PERMIT

SEWAGE DISPOSAL SYSTEM

HOWARD COUNTY HEALTH DEPARTMENT

SUBDIVISION Deer Track LOT 2 ROAD 6736 Cortina Drive

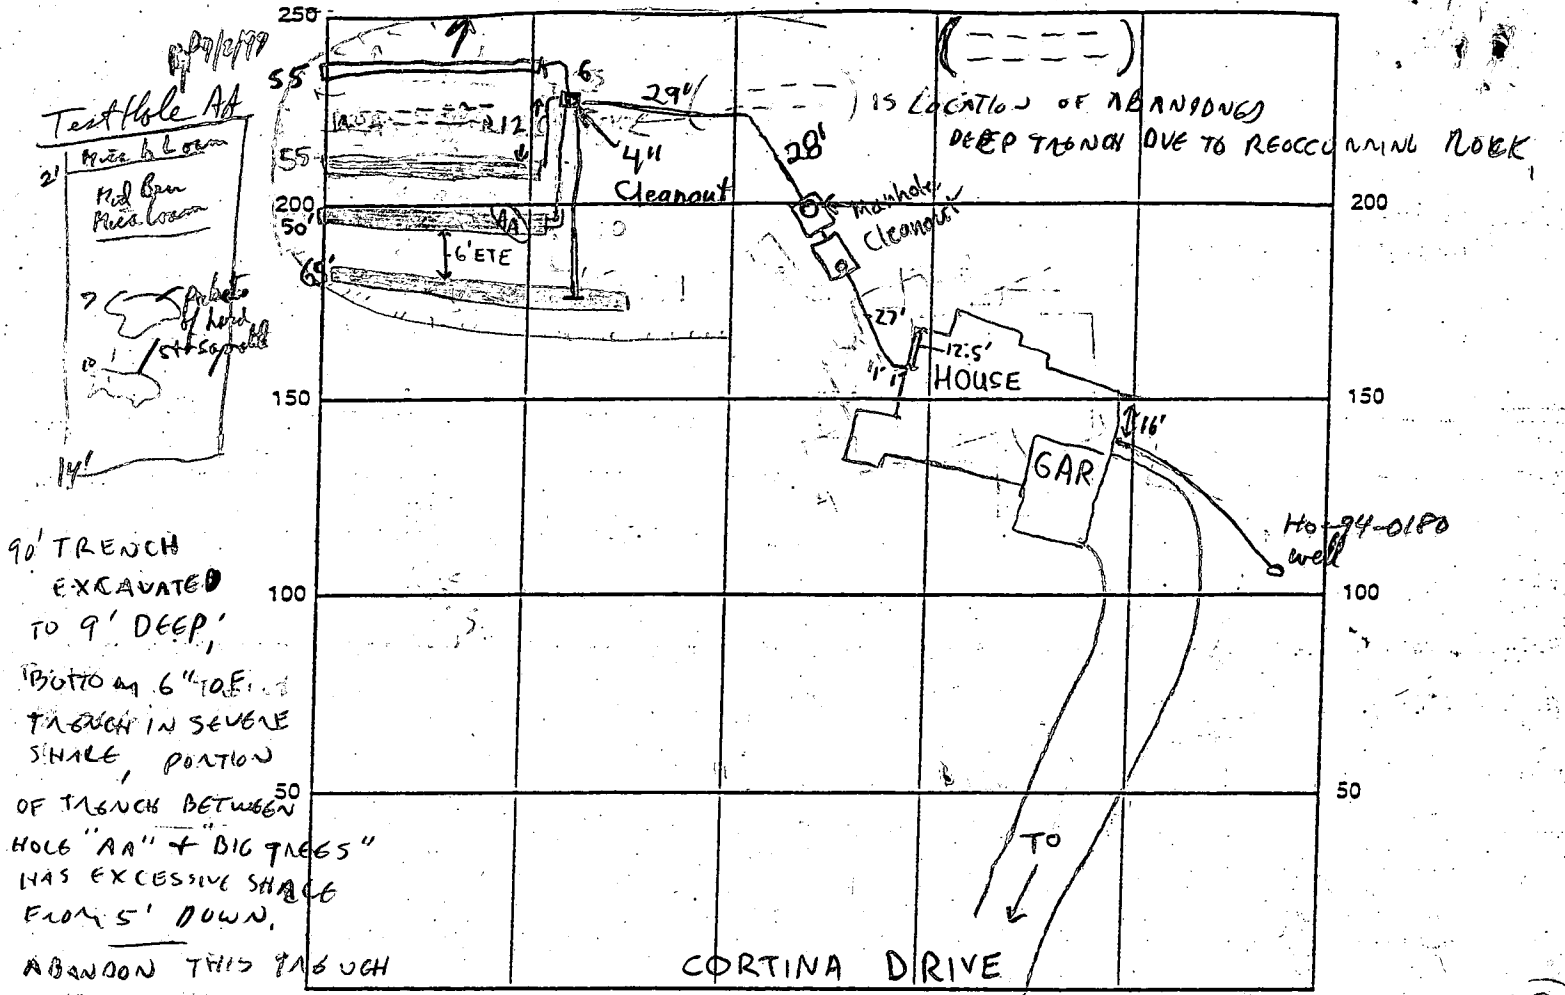
90' TRENCH EXCAVATED TO 9' DEEP; BOTTOM A 6" TO E. TRENCH IN SEVERE SHALE, PORTION OF TRENCH BETWEEN HOLE "AA" + "BIG TRENCHES" HAS EXCESSIVE SHALE FROM 5' DOWN. ABANDON THIS TRENCH

AND INSTALL SHALLOW SYSTEM INDICATE NORTH - NAME ADJOINING ROADWAY AS BASE LINE AS SPECIFIED IN AMENDMENT ON FRONT SIDE OF PERMIT. - PUMPED SYSTEM NEEDED. 9/3/99 (EW)

REMARKS: 9/3/99-Well will need 2 piece cap prior to WPI approval, OK TO CONTINUE WORK; SRW CONTRACTOR ABLE TO FIT A 65' TRENCH & A 50' TRENCH 6' APART OK; WILL TRY TO FIT A 55' TRENCH IN & LASTER TRENCH ON THE OTHER SIDE OF THE ROCKY TRENCH WHICH WILL BE AS LONG AS POSSIBLE (NEEDS ANOTHER TANK SET IN ORDER TO CONVERT TO PUMP SYSTEM -SRW) 9/10/99 TRENCHES COMPLETE. (EW) 9/19/99 O.K. To cover everything. Final approval pending pump test. 2 Piece cap on well. (BB)

11/30/99 Pump and alarm O.K. (BB)

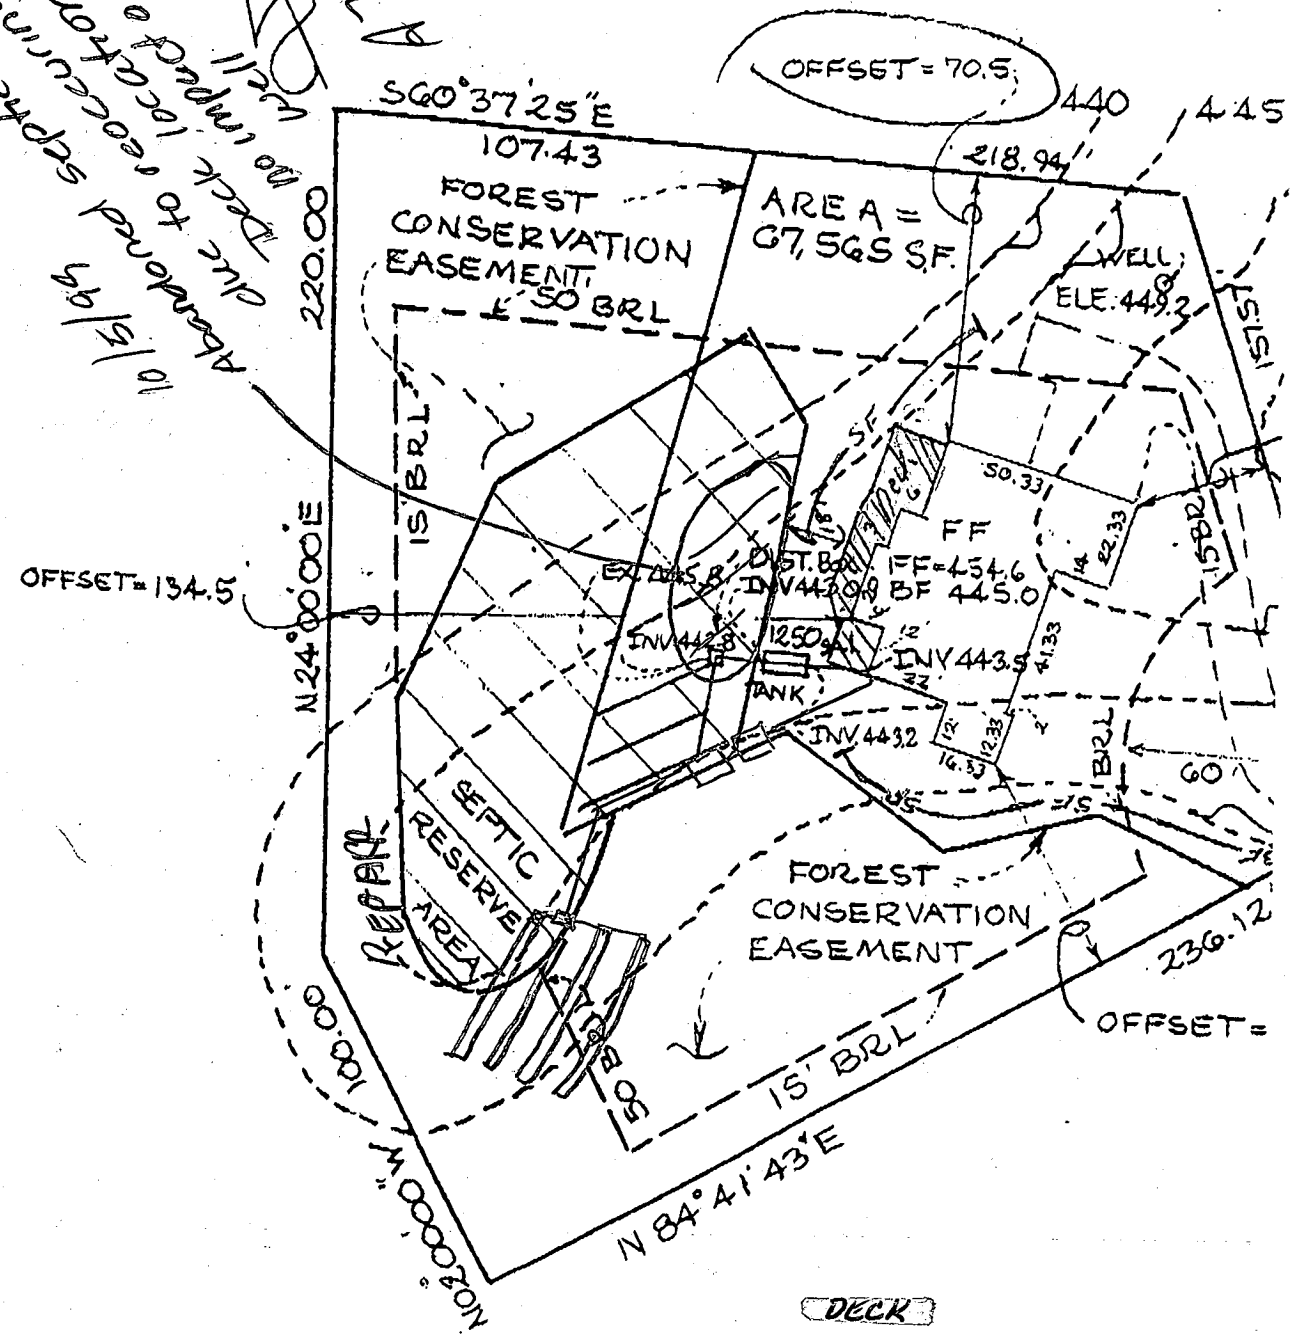
*10/5/99
Abandoned septic area
Deck to reoccur on rock
location will have
no impact on septic or
well.*
